Ref.: Draft Report – Network Planning and Expansion – Reference EPR0015
TP/CP

Draft Report – Review of National Framework for Electricity Distribution Network Planning and Expansion

Ergon Energy Corporation Limited
**Draft Report – Review of National Framework
for Electricity Distribution Network Planning
and Expansion**
– Submission
Australian Energy Market Commission
13 August 2009

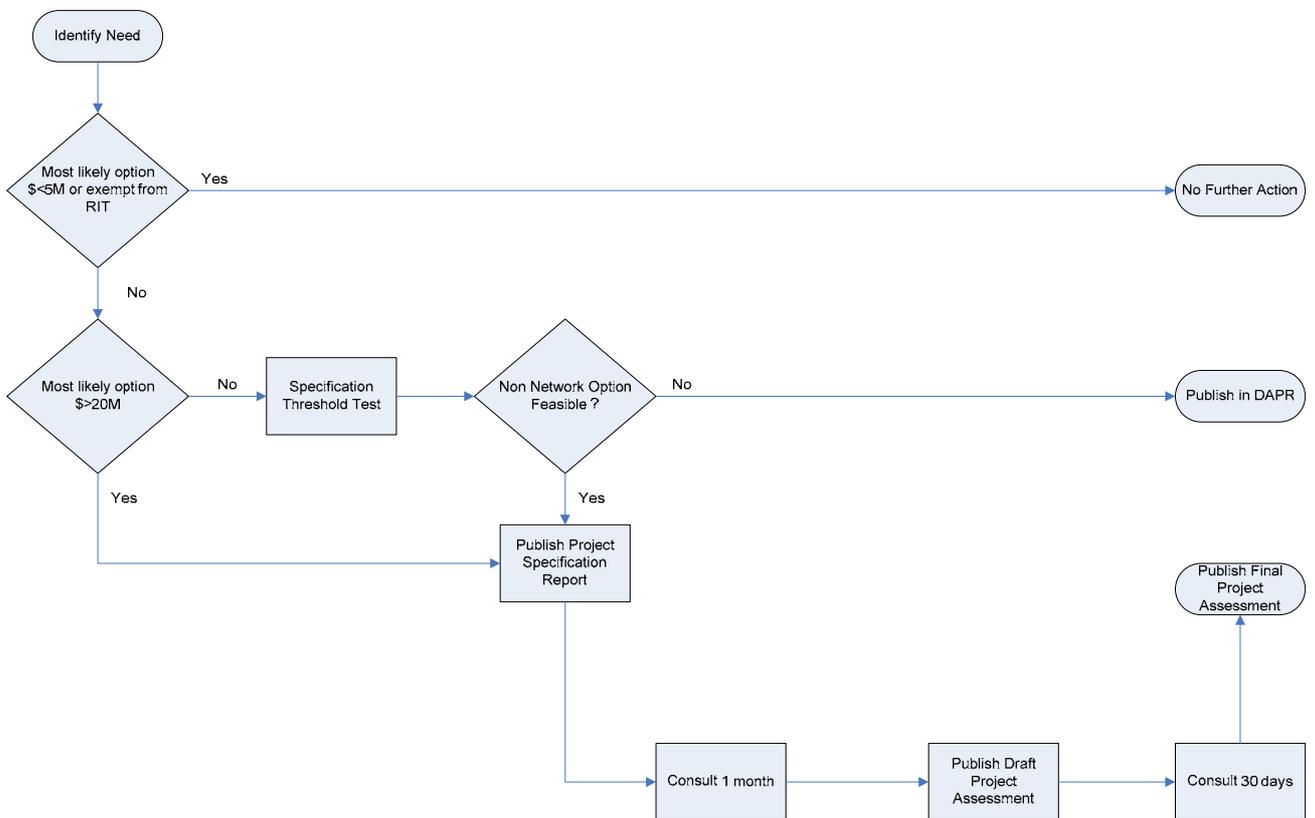
Similar to the ENA, Ergon Energy supports a simplified process. Ergon Energy considers the following process offers a more streamlined approach to undertaking the RIT-D than that proposed by the AEMC and provides a better balance between the benefits of transparency and the costs to DNSPs (and ultimately customers).

As illustrated above, Ergon Energy supports a process whereby:

- A DNSP identifies a need;
- If the most likely option for addressing the need is less than \$5 million no further consultation or reporting is required;

- If the most likely option for addressing the need is greater than \$5 million and less than \$20 million then the DNSP undertakes the Specification Threshold Test (STT);

- If the DNSP determines that the identified need satisfies the STT then no further separate reporting is required. The DNSP will provide a summary of all projects that met the requirements of the STT in the DAPR. This will be a high level summary including:

- The identified need;
 - Why the need exists;
 - Details of why a non-network solution was not feasible; and
 - Details of the network solution.
- If the DNSP determines that the identified need does not meet the STT then the DNSP will publish a Project Specification Report;

- The DNSP will also be required to publish a Project Specification Report for all identified needs where the most likely option for addressing the need is greater than \$20 million;

- A one month consultation period applies prior to the DNSP publishing its Draft Project Assessment Report;
- If the DNSP is required to publish a Draft Project Assessment then a further consultation period of 30 business days applies prior to the DNSP publishing the Final Project Assessment;

- The Dispute Resolution Process applies only in respect of investments that have proceeded to the Final Project Assessment Report stage.
